MINERALS PROGRAM INSPECTION REPORT

MINE NAME: Cresson Project	MINE/PROSPECTING ID#: M-1980-244	MINERAL: Gold and silver	COUNTY: Teller
INSPECTION TYPE: Monitoring	WEATHER: Clear	INSP. DATE: April 20, 2023	INSP. TIME: 09:30
OPERATOR: Cripple Creek & Victor Gold Mining Company	OPERATOR REPRESENTATIVE: Tony Matarrese & Josh Adams	TYPE OF OPERATION: 112d-3 - Designated Mining Operation

Photo 1. WHEX Clay Borrow Area (Excavation ends at toe of EMP 018, looking SSW)

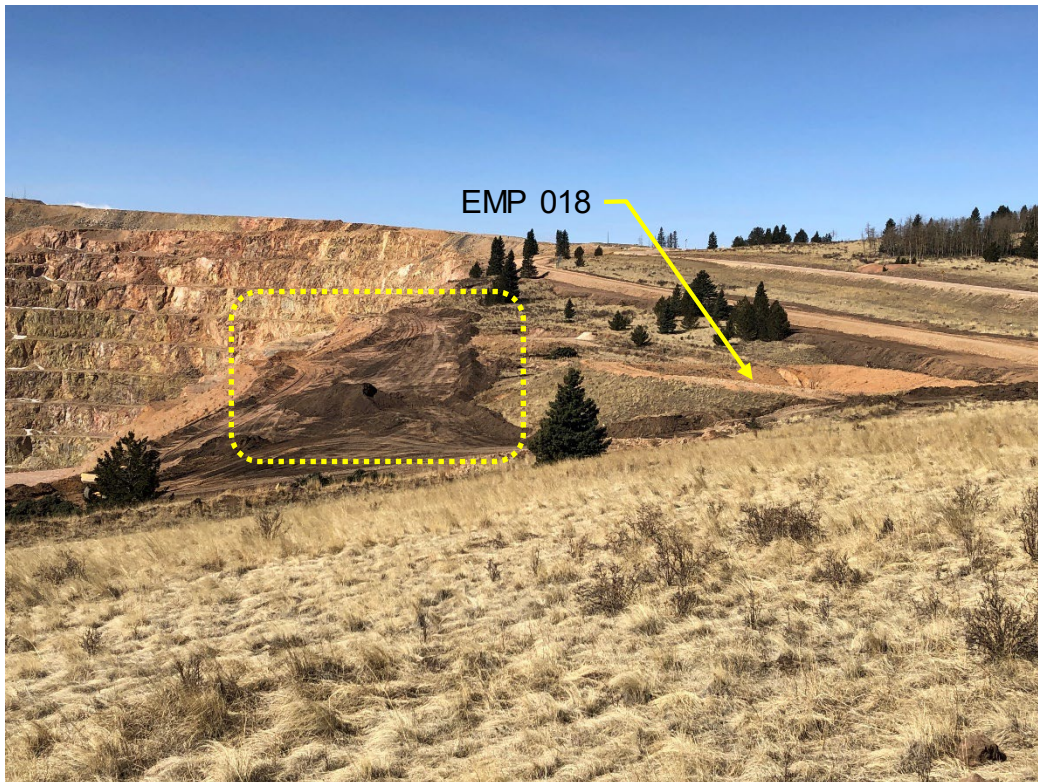
WHEX Clay Borrow Source: Messrs. Matarrese and Adams accompanied the DRMS to the WHEX Clay Borrow Source, where Jeff Gaul (CC&V). Mr. Gaul stated they had moved roughly 1,000 cubic yards to the staging area near the VLF 2 phase III construction area and that the mine expects to be finished with excavations in this borrow area in early June. He also pointed out the excavation of the clay material is limited to the area south of the toe of EMP 17 (see **Photo 1**). CC&V is installing a fence to delineate the northern extent of the clay borrow area.

Photo 10. PGMW-5 location – west of EMP 022B.

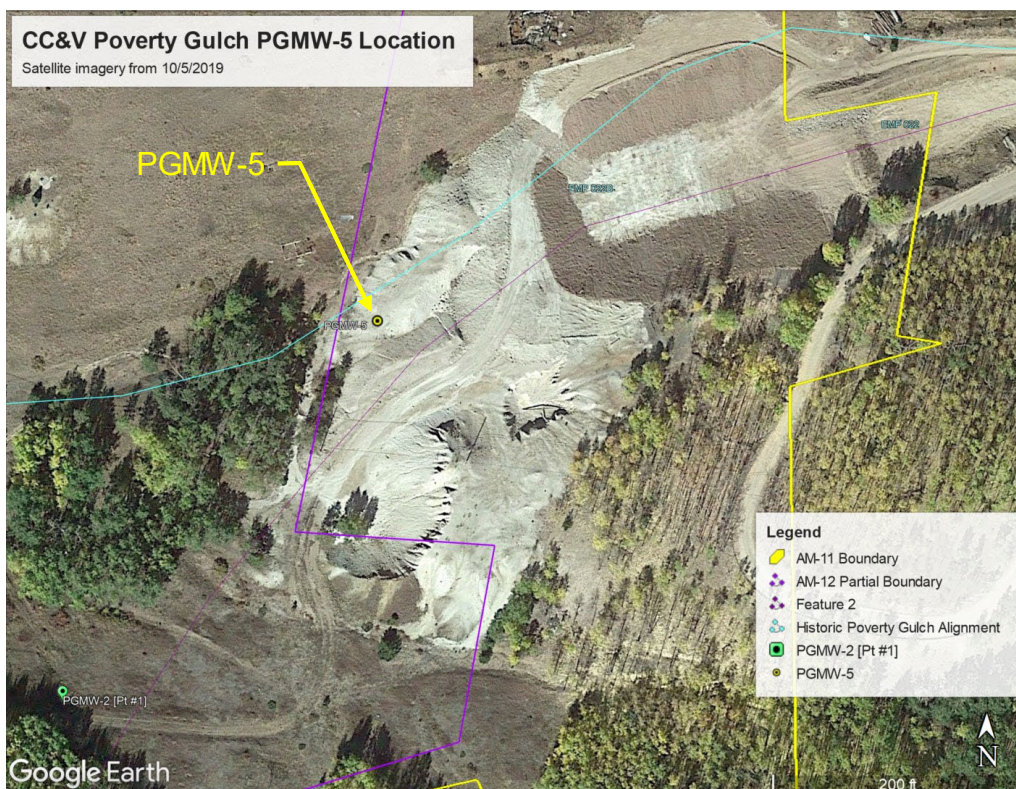
PGMW-5: A quick trip to the newly installed PGMW-5 monitoring well was requested by the DRMS to observe its location (see **Photo 10**). The location was obtained using this inspector's iPhone to provide an approximate location (38.746069°, -105.168222°). Mr. Matarrese stated the water in the well was muddy and he was continuing to develop it. The well ID was welded onto the casing (see **Photo 11**).

Photo 12. VLF 2, Phase III leak detection system trench (left arrows) construction (looking WSW).

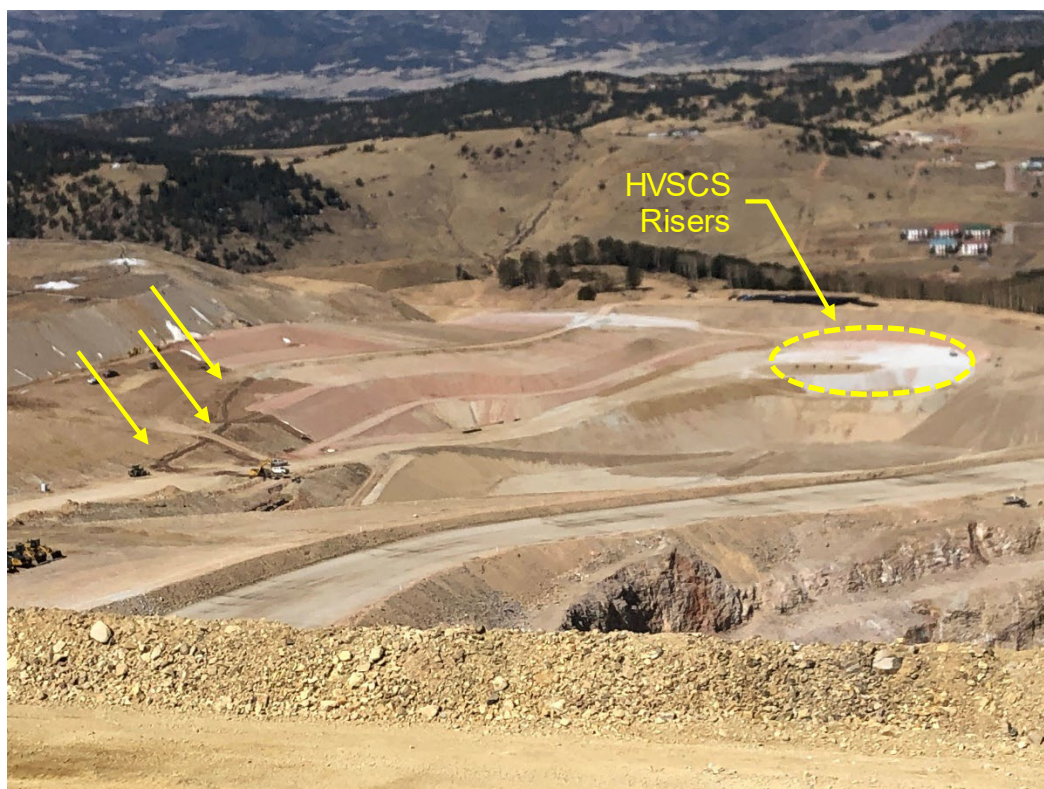
VLF 2 Phase III construction: Mr. Jeff Gaul was present for the overview and status update for the Phase III construction in the Schist Island pit. Mr. Gaul stated they were installing a leak detection trench (see **Photo 12**).
